Invitation of public comments

Sub: Permission for crossing of 33KV Over head lines at NH-04 at Shree Rambapuri College Shiggaon-Reg

Subject: Six Laning and Strengthening of km 340+000 to km 403+400 of Hubli-Haveri section of NH-48 (Old NH-4) in the State of Karnataka to execute on Hybrid Annuity Mode under NHDP Phase-V.-**Proposal for Crossing of 33 KV Over Head Line at NH-4. IE Observations. Reg: -**

SKETCH SHOWING TOWERS FOR NATIONAL HIGHWAY-4 CROSSING OF 33KV SC LINE ON DC TOWERS
AT SHIGGOAN, CONDUCTORS ARRANGEMENT DESING

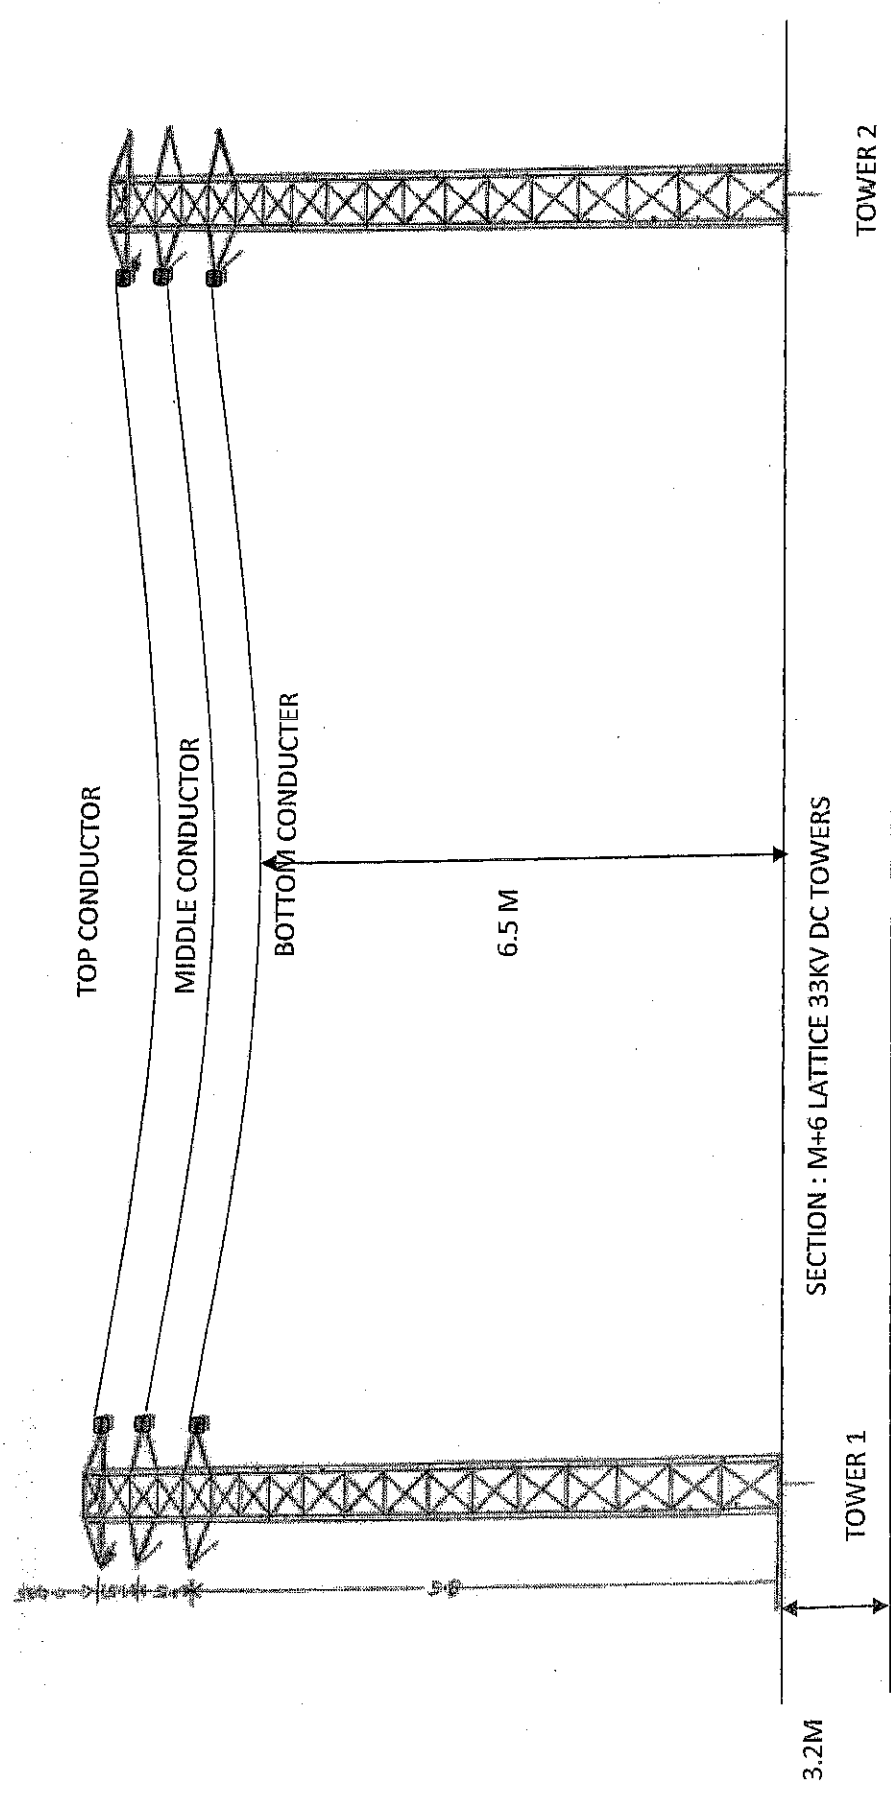
The LME level at 364.965 is 620.069 M and the RME level at same location is 620.028. And the lower conductor of the lattice girder is at an elevation of 9.100 M at LME and 9.700 M at RME and conforms to the guidelines of 9.5 M in the sketch and is safe. Further considering the undertaking given by the utility department vide HESCOM HAVERI Lr no. 72 Dt. 17-11-2017, further necessary action may be taken from your end.
